In the Matter of
LONG ISLAND LIGHTING COMPANY
(Shoreham Nuclear Power Station, Unit 1)
Docket No. 50-322-1 (OL)

AFFIDAVIT OF CLINTON S. MATHEWS

Subject: Crankshaft Oil Hole Plug
P/N R-3149

PLUG, CRANKSHAFT OIL HOLE

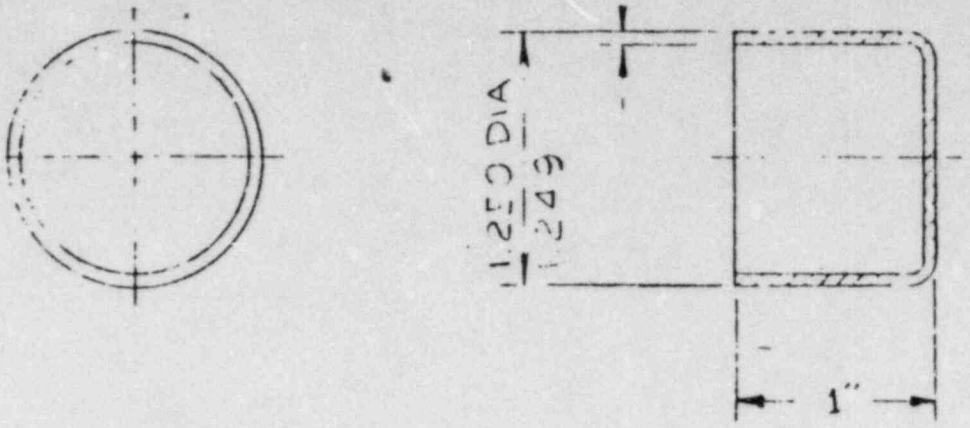
MATERIAL WAS 16 GUAGE (.0595) STEEL SHEET STAMPING.

REASON: EASE OF ASSEMBLY

MATERIAL WAS 22 GA. (~~.0229~~) COLD ROLLED STL.

REASON: TO LESSEN CHANCE OF DAMAGE TO PLUG AT INSTALLATION

B 6-15-82 MATL WAS 22GA (.029") STL SHT

A 2-2[illegible] STL SHT

16 GAGE COLD ROLLED DRAWING QUALITY SHEET STAMPING

PLUG, CRANKSHAFT OIL HOLE

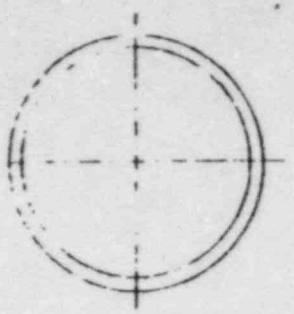
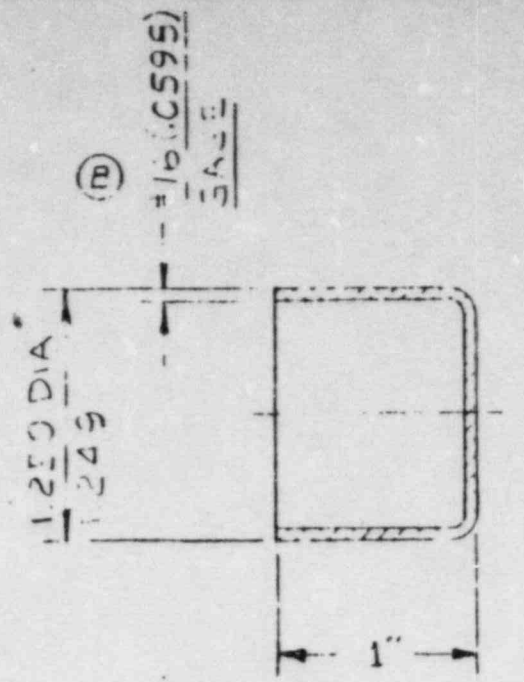
MATERIAL WAS 16 GUAGE (.0595) STEEL SHEET STAMPING.

REASON: - EASE OF ASSEMBLY

MATERIAL WAS 22 GA. (~~.0229~~) COLD ROLLED STL.

REASON: TO LESSEN CHANCE OF DAMAGE TO PLUG AT INSTALLATION

B 6-5-82 MATL WAS .22GA (.029) STL SHT
A 2-2-...

16 GAGE CRS FLAT DRAWING
QUALITY SHEET STAMPING

PLUG, CRANKSHAFT OIL HOLE

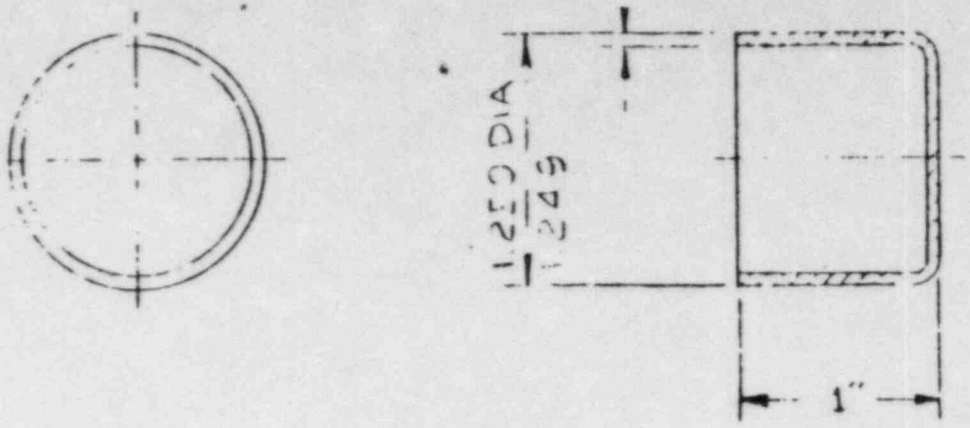
MATERIAL WAS 16 GUAGE (.0595) STEEL SHEET STAMPING.

REASON: EASE OF ASSEMBLY

MATERIAL WAS 22 GA. (~~.0229~~) COLD ROLLED STL.

REASON: TO LESSEN CHANCE OF DAMAGE TO PLUG AT INSTALLATION

B 6-5-82 MATL WAS .22 GA (.0295) STL SHT

16 SAME AS DETAIL DRAWING

PLUG, CRANKSHAFT OIL HOLE

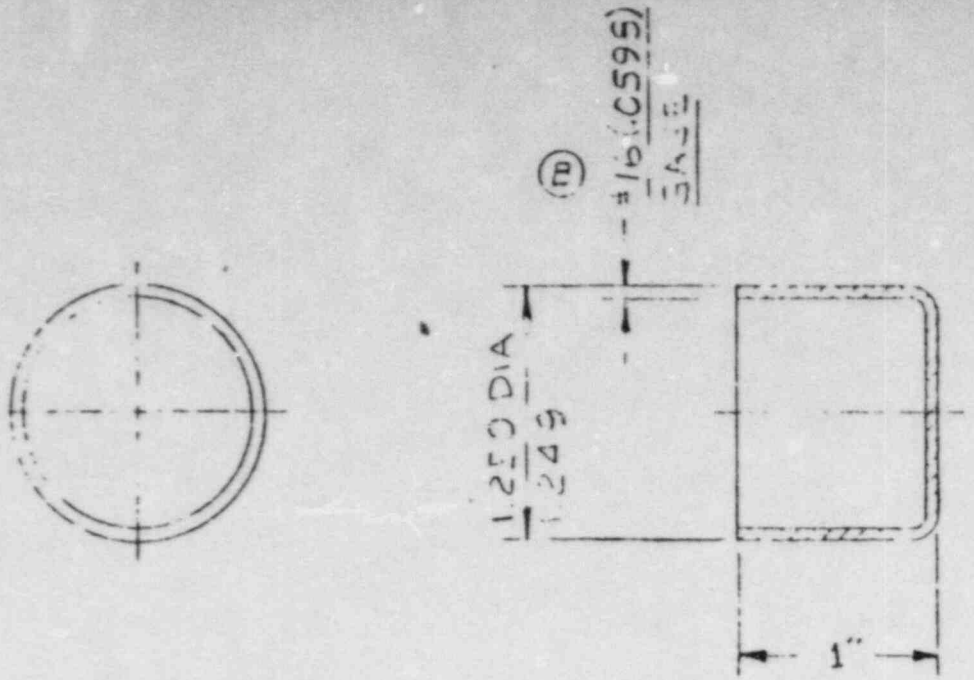
B 6-5-92 MATL WAS .22GA (.0299) STL SHT

16 GAGE CR ... PLATE DRAWING

QUALITY SHEET STAMPING
